**CALIFORNIA COASTAL COMMISSION**

## **APPEAL STAFF REPORT: SUBSTANTIAL ISSUE DETERMINATION ONLY**

**Appeal Number:** A-3-SCO-16-0070

**Project Description:** Construct a 3,637-square-foot, two-story, three-bedroom, three-and-a-half bathroom single-family residence with a 540-square-foot garage; install a buried gabion basket retaining wall to address an existing landslide mass.

UPDATED SITE PLAN AND ENGINEERING GEOLOGIC MAP					
<b>UPP GEOTECHNOLOGY</b> a division of <b>C2EARTH, INC.</b>		GRAVES PROPERTY APN 038-231-09 New Brighton Road Santa Cruz County, California			
		DRAFTED/REVIEWED	SCALE	DOCUMENT ID.	DATE
CH		As Shown	14053A-01L1	December 2014	Figure 1

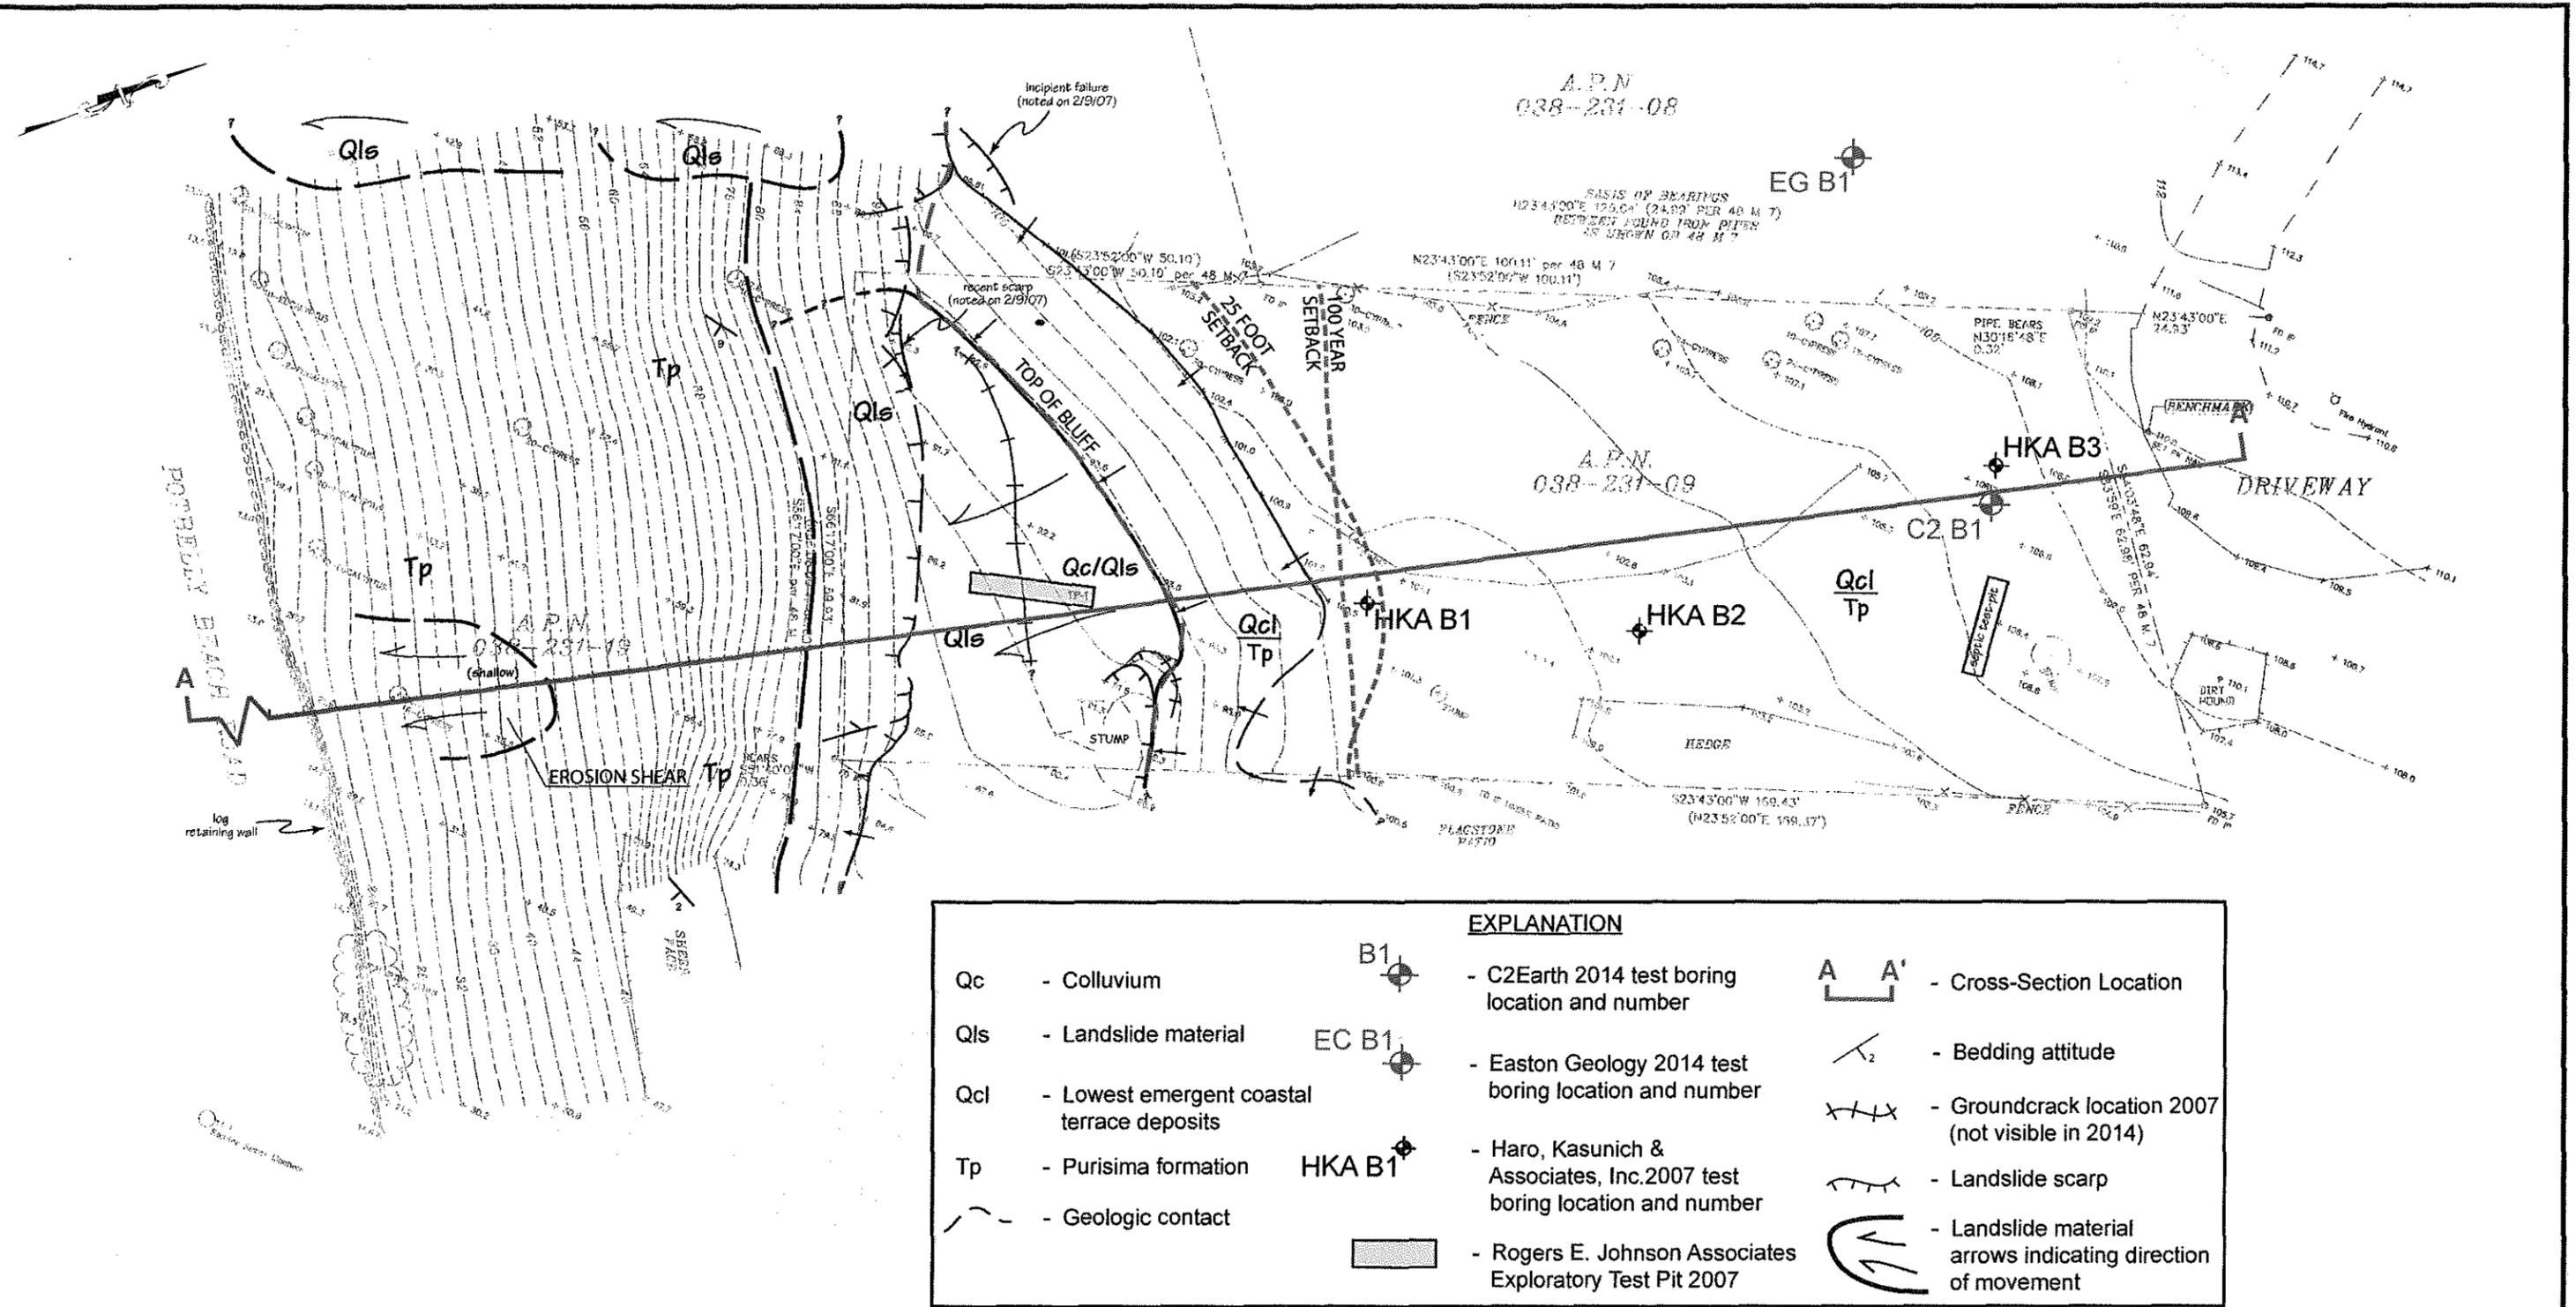
As we noted in our December 31, 2015 letter, the project plans provided for review noted the requirement for a 50-foot bluff setback (Plan Sheet A1.0 dated 6/18/15). In response to our comments pointing out this discrepancy, the geotechnical consultant responded that the 50-foot setback noted on the project plans was "a typo." However, that response does not adequately explain why the 50-foot setback recommended in the August 13, 2014 was changed. Moreover, we were not provided with the reports from 2007 and have not been able to evaluate their findings or recommendations. Finally, the reports that were provided do not appear to provide an erosion rate for the area in order to establish an appropriate bluff setback for a 100-year life of the structure. Given the above, and the history and geologic instability of the site, we believe that an independent peer review of the geologic and geotechnical analysis studies is warranted.

1. **Geologic Report.** The routing materials reference a geotechnical report; however, the report was not provided to Commission staff. Plan Sheet A 1.0 appears to indicate a discrepancy in the required bluff setback in that a 25-foot line is indicated on the drawing, but the plan sheet text appears to call for a 50-foot setback. Because of this discrepancy, we request that a copy of the Geologic Report be provided if there is an electronic copy of the report. Pursuant to LCP Policy 6.2.12, please ensure that the setback is sufficient to provide a stable building site over the 100-year lifetime of the structure, as determined through geologic and/or soil engineering reports. Because the project is proposing "new" development, the determination of the minimum 100 year setback shall be based on the existing site conditions and shall not take into consideration the effect of any shoreline or coastal bluff protection measures. See, also IP Section 16.10.070(H).

In this case, the plans appear to state that the necessary bluff setback was determined to be 50 feet (see Plan Sheet A 1.0), yet the patio appears to be within 25 feet of the bluff's edge, and the home is within the 50 foot required setback. The house should be appropriately located so that the required 50 foot setback is met. Additionally, it appears that gabion baskets will be installed. IP Section 16.10.040 defines shoreline protection as "any structure or material, including but not limited to riprap or a seawall, placed in an area where coastal processes operate." Since gabion baskets are a form of shoreline protection, and all new development must be set back without reliance on engineering structures, the proposed gabion baskets are inconsistent with the LCP.

Our 100-year and 25-foot setbacks and our determined “top of bluff” based on the Coastal Commission's procedures are presented on Figure 1, Updated Site Plan, and Figure 2, Updated Geologic Cross-Section. We conclude, therefore, that the two setbacks should be combined: in the eastern and western portions of the site, the 100-year setback will govern, and in the central portion of the site, the 25-foot setback will govern. It should be noted that the building envelope beyond these setbacks is also beyond the limits of the shallow landslide and previously identified ground cracks.
